Texas Independent Producers and Royalty Owners Association
919 Congress, Suite 1000, Austin, Texas 78701, (512) 477-4452, fax (512) 476-8070

December 17, 2018

Re: Environmental Protection Agency's Oil and Natural Gas Sector: Emission Standards for New, Reconstructed, and Modified Sources Reconsideration at 83 Federal Register 52056 (October 15, 2018)

Docket ID No. EPA-HQ-OAR-2017-0483

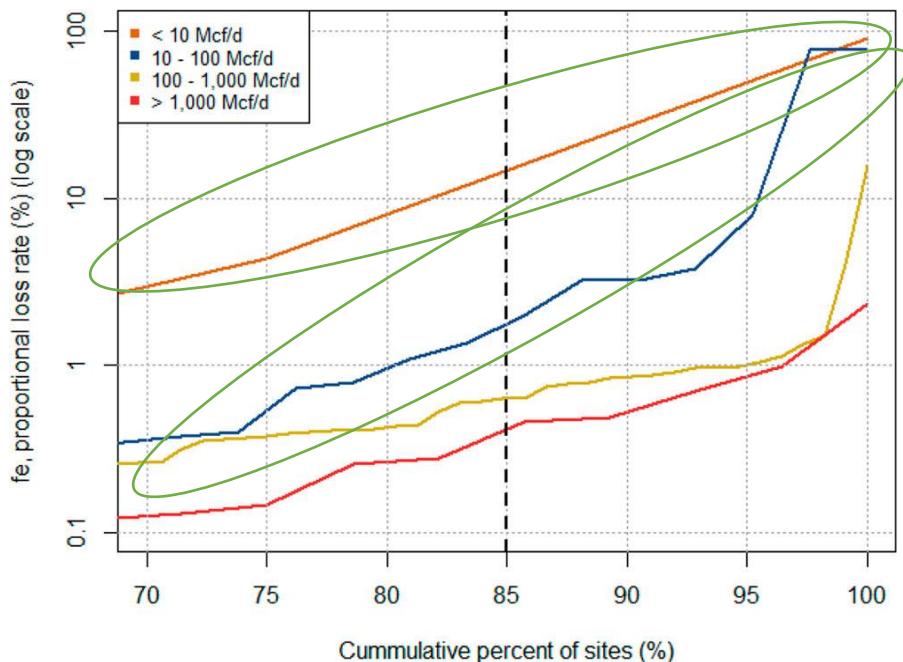
With the presentation of the same material in the study demonstrates how it was manipulated. Below is the graphic used to present the data. It would suggest that the worst emitting operations – the "super-emitters" – are the smallest wells (the orange line and the blue line, circled in green). Having directly plotted this data, the obvious issue is how such a result can occur.

It is a busy and confusing graph – it is intended to be. The study uses data analysis tricks to create the appearance that low production wells are "super-emitters."

First, it shows emissions as a percentage of production rather than actual emissions. Thus, one mcf emitted out of ten mcf produced is 10 percent, but 50 mcf emitted out of 1,000 mcf produced is five percent. As a result, it skews the perception of the data to imply that low production wells are large emitters when they are not.

Second, its production volumes are really sales volumes, not the amount extracted from the wellhead. Consequently, a "proportional loss rate" of 50 percent would be the calculated loss divided by the volume sold. If the percentage of loss was calculated based on extracted volumes, the 50 percent "proportional loss rate" would drop to 33 percent because the loss would be added to the sales volume to obtain the extracted volume.

Third, it only shows data from the 70th percentile of information. This excludes all of the virtually zero emissions that dominate the data.

Fourth, it uses a logarithmic scale to present the data. One of the reasons to use logarithmic scales is to flatten curves to make them look more like straight lines.
